PLANNING DEPARTMENT

Re: **Public Hearing** – Request of Valley Rd. MOB, LLC for modification to the building design for a previously approved Development Plan Review application for a proposed medical office building, including requested waivers from certain design requirements of Section 521 of the Middletown Rules and Regulations Regarding the Subdivision and Development of Land. Property located on Valley Rd. approximately ¼ mile north of the intersection of Valley Rd. and East Main Rd., Tax Assessor's Plat 107NE, Lot 402B.

4 PROPOSED EAST ELEVATION
SCALE: 1/8" = 1'-0"

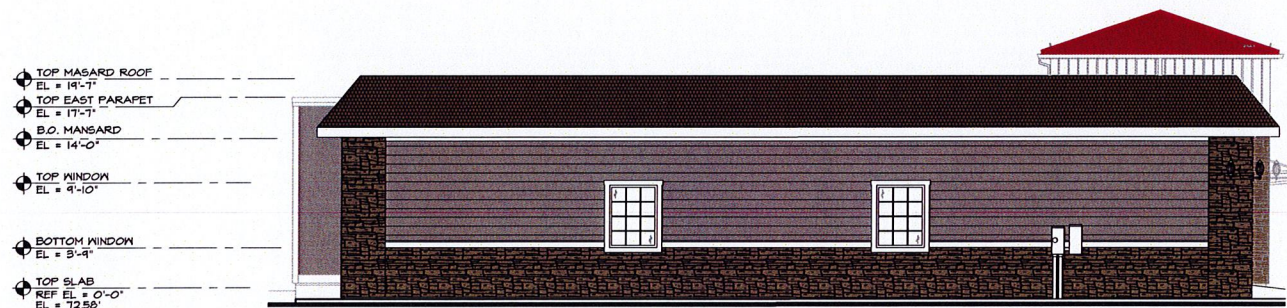
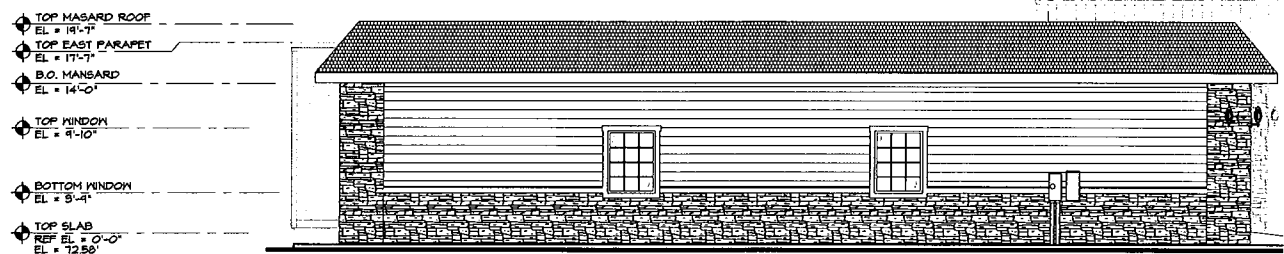
The applicant for the above reference project, which was previously approved by the Planning Board, is seeking approval to modify the building design. Attached are the approved building elevations and the proposed revised elevations. The revised elevations indicate some changes to the exterior facades, including to the number and location of windows on the east and north facades.

3 PROPOSED NORTH ELEVATION
SCALE: 1/8" = 1'-0"

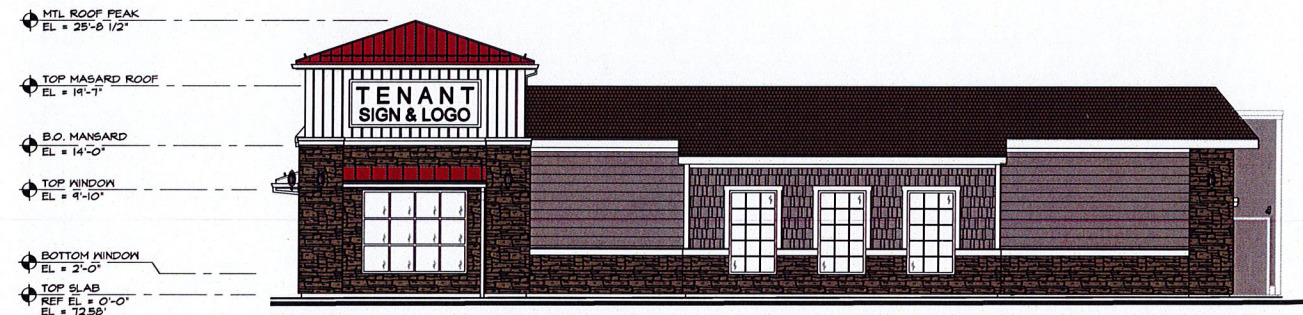
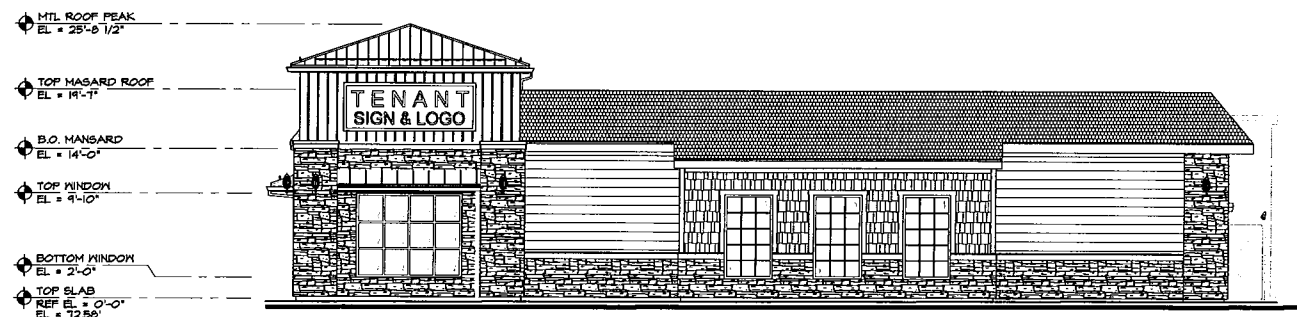
Below are the waivers previously approved (the complete Planning Board decision is attached). It appears that an additional waiver for not meeting the minimum area of windows on the north facade would be required.

1. **Section 521.2.B. 1 & 2** – Windows must make up 20% – 60% of each façade and be of true or simulated divided-light design. **The amount of window glazing on façade(s) visible from the public way does not meet this requirement.**
